SUBDIVISION COMMITTEE REPORT

R2014-00025

Vesting Tentative Tract Map No. 072630
Conditional Use Permit No. 201400001
Oak Tree Permit No. 201400002
Environmental Assessment No. 201400002

VESTING TENTATIVE MAP
TRACT NO. 72630
S R C WEST, INC. SURVEYING
 2937 RIE CANYON ROAD, SUITE 201, SMITH CLARK, CA 91356
 Phone: (818) 257-8970, Fax: (818) 257-8977

SHEET NO. **2**
 OF 3 SHEETS

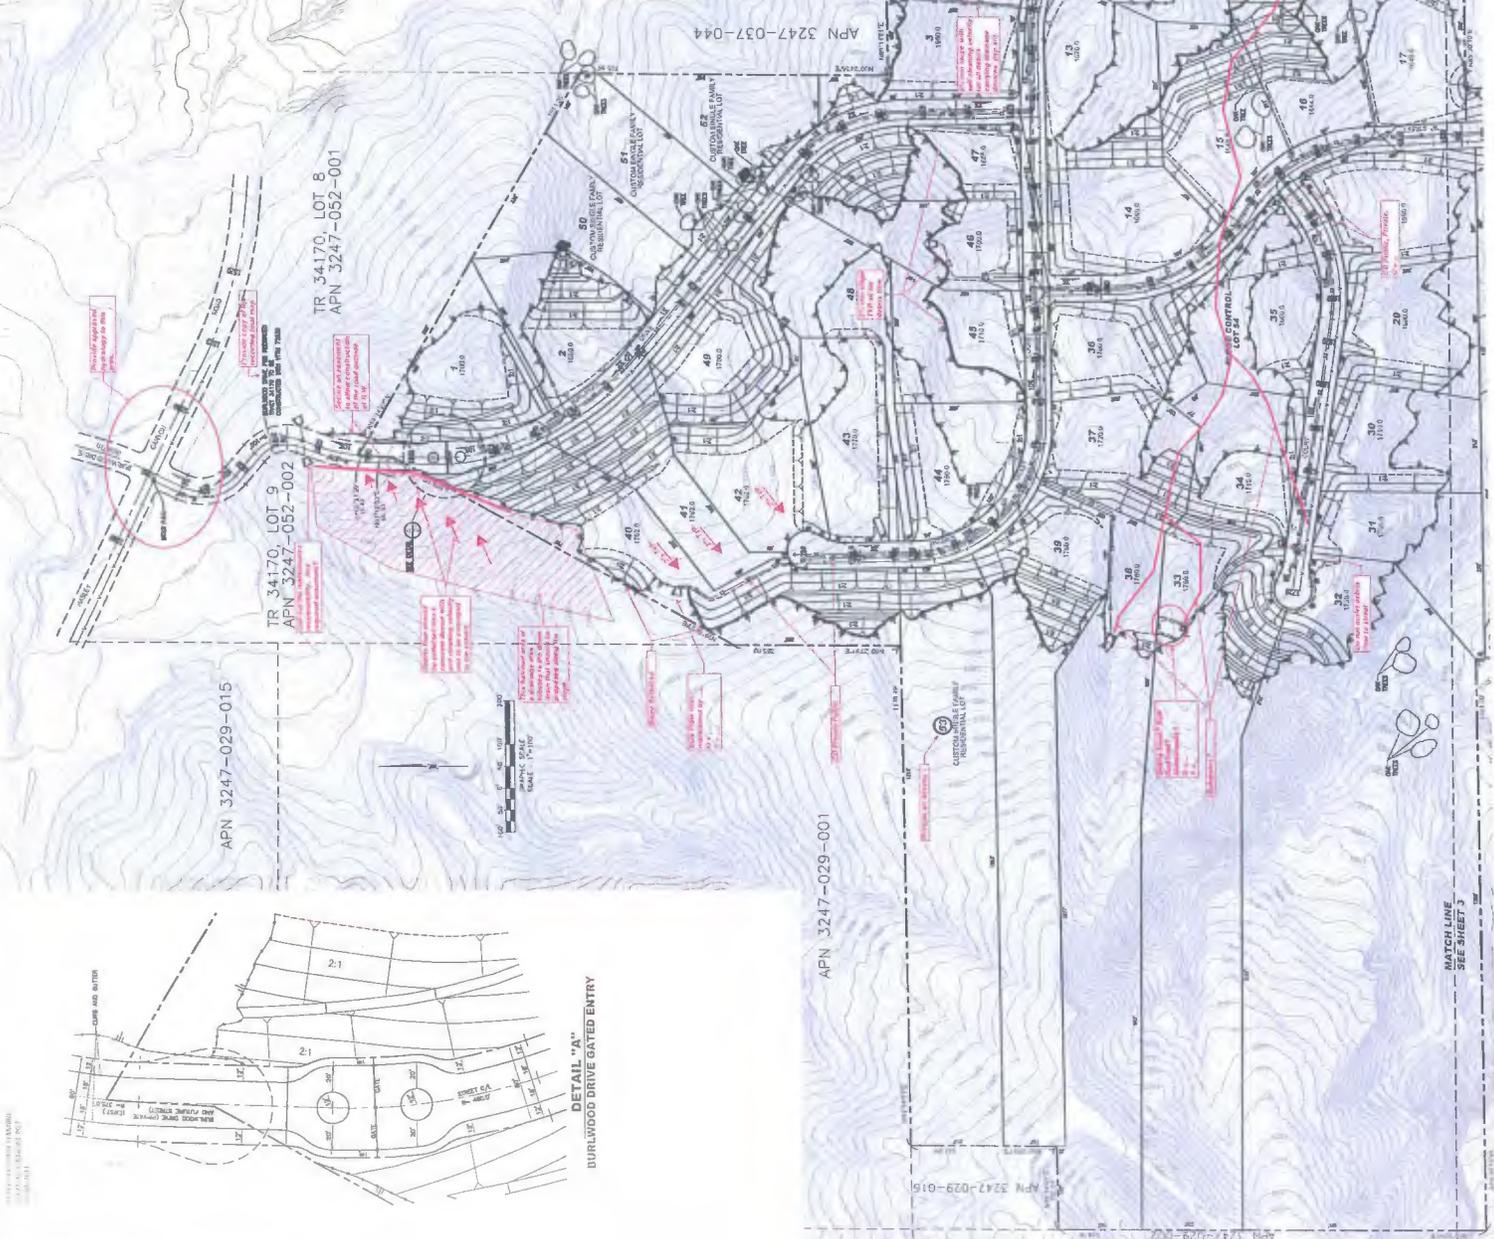
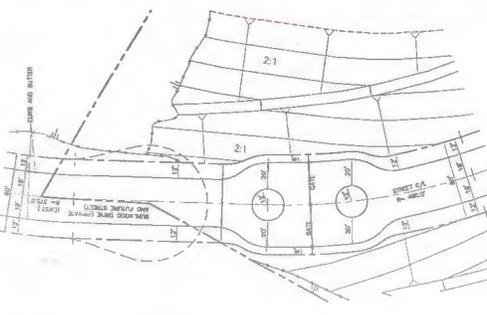
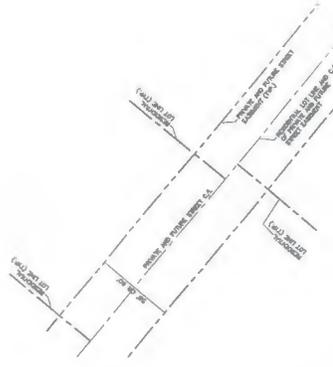
1. Please label sheets 2 and 3 as ~~Map~~ Exhibit ~~Map~~.
2. Include calculation and labeling of open space, which must be 70 percent of the total net area.

5. The continuation of ~~Map~~ Street south of the project site is depicted as a future street. Delete this extension or include the property as part of the project proposal.

- n. Provide complete grading for E Street at the tract southern boundary to grade for the road. There is 60' difference in elevations between the existing and proposed grades..
